# **ARCHITECTURAL ADVISORY COMMITTEE MEMORANDUM**

DATE: June 7, 2021

SUBJECT: REQUEST BY BRENDA AYALA, ON BEHALF OF EL SALVADOR CAFÉ, FOR MINOR ARCHITECTURAL REVIEW APPROVAL TO INSTALL A 256-SQUARE-FOOT CANOPY STRUCTURE AND A RAILING FOR AN OUTDOOR DINING AREA EXPANSION AT AN EXISTING RESTAURANT LOCATED WITHIN THE SUNRISE SQUARE SHOPPING CENTER AT 1750 NORTH SUNRISE WAY SUITE F-2 (APN: 501-600-013), ZONE CDN, SECTION 2 (CASE 3.1870 MAA). (NK)

*Image 1.5. Proposed Canopy Structure*

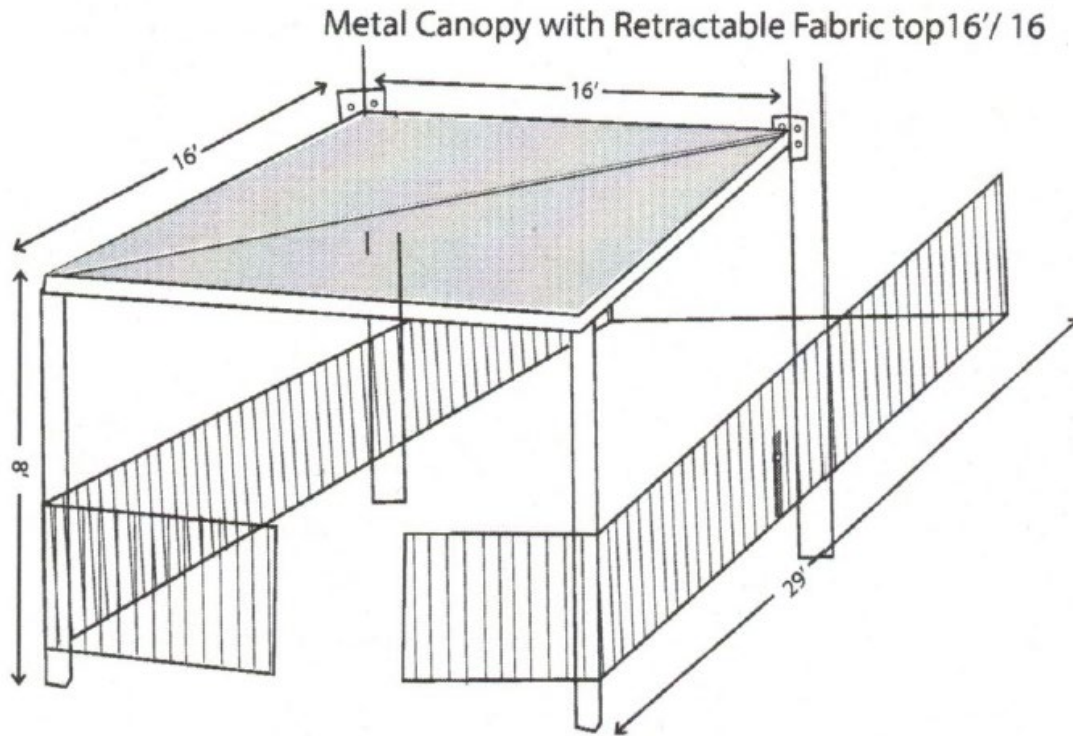
1. The color palette of the Sunrise Square Shopping Center consists of earth-tone colors such as white, beige, and brown, and the proposed blue shade sails create striking color contrast against the building background.
2. The subject business is closely located to another restaurant, Loco Charlie, which provides an outdoor dining area developed with a canopy structure and a railing. The proposed canopy design is not identical to the one installed at Loco Charlie. Although City documents verify that the railing at Loco Charlie is permitted, there is no permit or approval record for the canopy.

1. The proposed shade sails shall be desert-neutral in color so that they will be compatible with the colors found at the Sunrise Square Shopping Center.
2. Specifications such as color, height, tubing size, and spacing, as well as the projection of the proposed railing shall be consistent with the one installed at the Loco Charlie restaurant.

4.	<p><b>Building design, materials and colors to be sympathetic with desert surroundings;</b></p> <p>The color palette of the Sunrise Square Shopping Center consists of earth-tone colors such as white, beige, and brown, and the proposed blue shade sails create striking color contrast against the colors found at the site. Staff is recommending a condition of approval, which requires the color of the shade sails to be desert-neutral and compatible with the colors found at the Sunrise Square Shopping Center.</p>	Yes, as conditioned

5.	<p><b>Harmony of materials, colors and composition of those elements of a structure, including overhangs, roofs, and substructures which are visible simultaneously;</b></p> <p>The proposed blue sail shades stand out against the building which exhibits desert-neutral color palette. As stated in #4 above, staff is recommending a condition of approval which requires the color of the shade sails to be compatible with the color theme of the Sunrise Square Shopping Center.</p>	Yes, as conditioned
